Coastal Access Modification Report GAL-MR1

Proposed changes to the submitted England Coast Path proposals
for Gretna to Allonby

Location affected: **Burgh Marsh/Burgh-by-Sands, Cumbria**

9th May 2022

Map GAL-MR1i - Restrictions and Exclusions

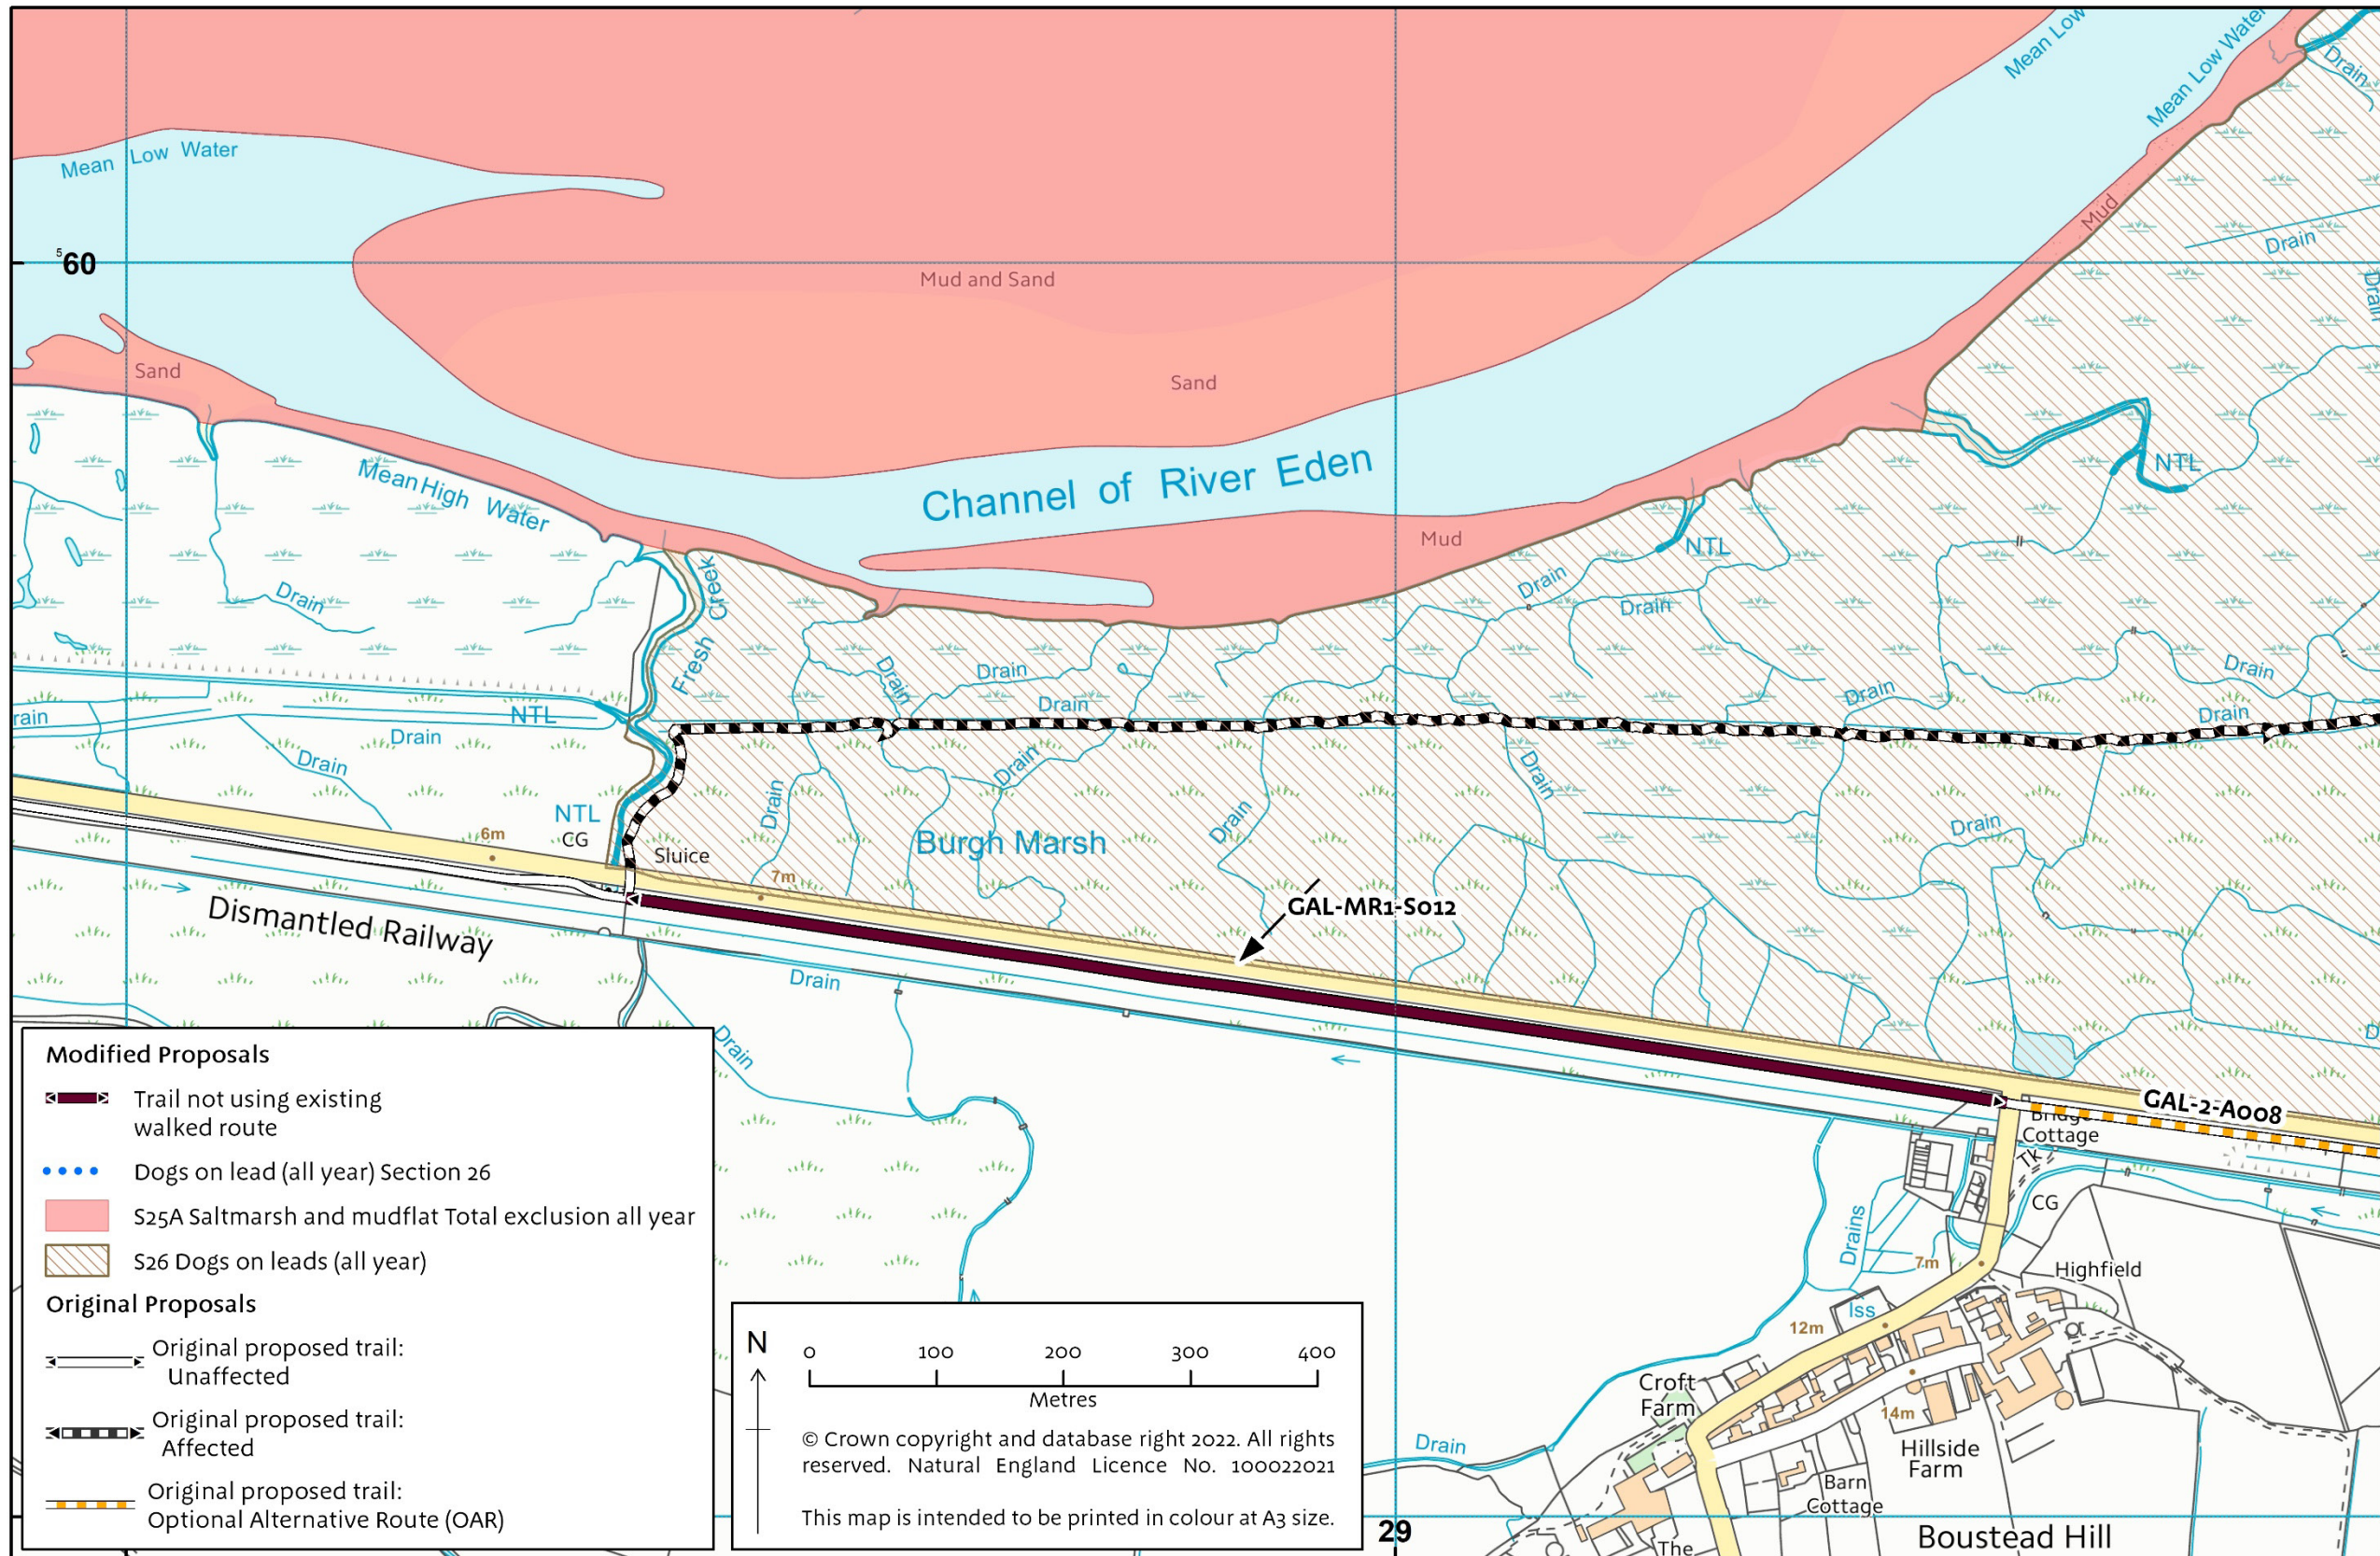
Where the proposed new route is aligned on the open marsh, it would continue to be subject to the existing proposed restriction with the effect that all dogs should be kept on leads at all times of the year.

Refer to 'Restrictions and Exclusions' maps below – GAL-MR1g/1h/1i.
